### ADAM-M 2.1 Vdc Power Supply Adjustment

# RTS™ TECHNICAL BULLETIN

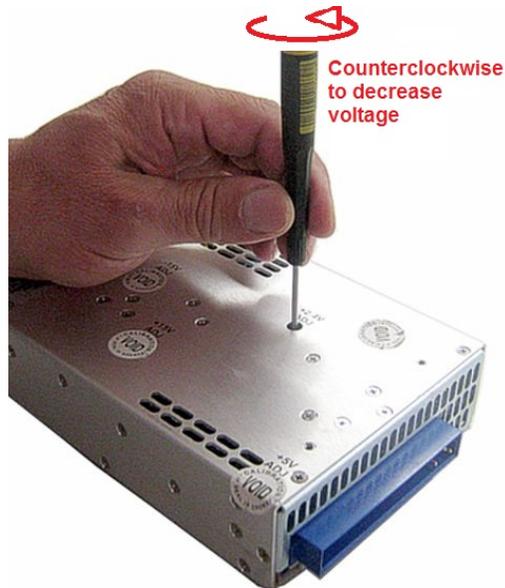
- 1) **Power off both AC/DC supplies in the ADAM-M Frame.**
- 2) Keep all system cards in the ADAM-M frame so that a static load remains on the power supply
- 3) Remove one (and only one) of the AC/DC power supplies
- 4) Locate the 2.1 Vdc rail adjustment opening on the top of the supply. It is labeled "+2.4V ADJ" and is identified in the picture below:

- 5) If a calibration sticker is present over this adjustment, remove the calibration sticker over this opening.  
**NOTE:** For the 2.1 Vdc rail (and only the 2.1 Vdc rail), removing this sticker and adjusting the voltage does NOT void the warranty.
- 6) Using a small flat blade screwdriver, turn the 2.1 Vdc rail potentiometer counterclockwise (about 1 to 1.5 turns if the supply started at a higher voltage). A flashlight is very helpful in completing this step.
